# RENESAS TECHNICAL UPDATE

Product Category	MPU/MCU		Document No.	TN-RX*-A023A/E	Rev.	1.00
Title	Note on Using Multi-Function Timer Pulse Unit 3 (MTU3) Interrupts		Information Category	Technical Notification		
Applicable Product	RX 62T Group, RX 62G Group, and RX 63T Group	Lot No.	Reference Document	RX62T Group User's Manual: Hardware		
		All lots		RX62G Group User's Manual: Hardware RX63T Group User's Manual: Hardware

1.2 Permanent Countermeasure

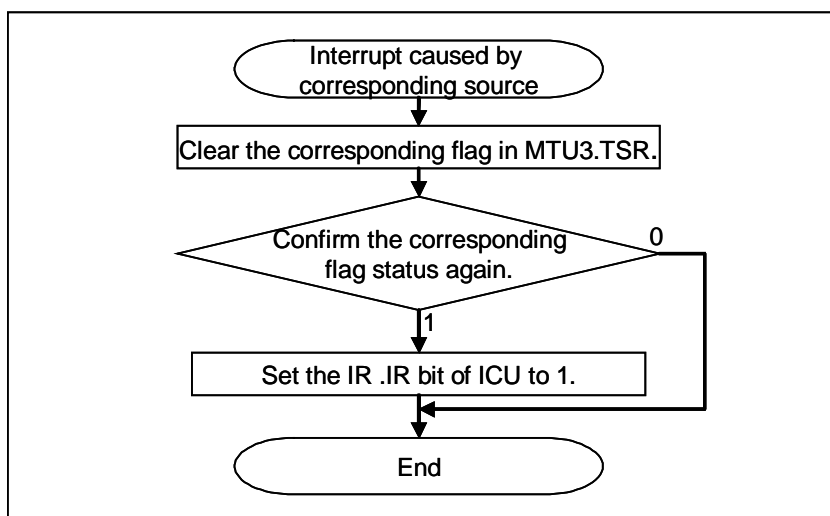
If a status flag (\*1, \*2, and \*3) in the timer status register (TSR) is cleared to 0 at a certain timing, no MTU3 interrupts may be issued to the CPU after that. The following gives the details.

The specified procedure for clearing a flag is reading 1 from the flag and then writing 0 to the flag as described in the manual (\*4). However, if the interrupt is generated after 1 is read from the corresponding flag before the flag is cleared to 0, the corresponding flag is not cleared but remains 1, thus disabling the clear-to-0 instruction as shown in the figure below. Once this condition occurs, if the interrupt is generated while the status flag is 1, the interrupt status flag in the ICU (IR bit in the IR register) is not set to 1 and thus any interrupt to the CPU is ignored (\*5). Consequently, if an interrupt is generated during the above period or after that before the status flag is reset next time, the interrupt is not processed. To prevent this, use the procedure that is given in section 1.2 to clear a status flag.

An interrupt request is ignored while the corresponding flag in the TSR is 1; to enable the interrupt again, clear the corresponding flag and take the preventive measures through software as shown in the flowchart below.
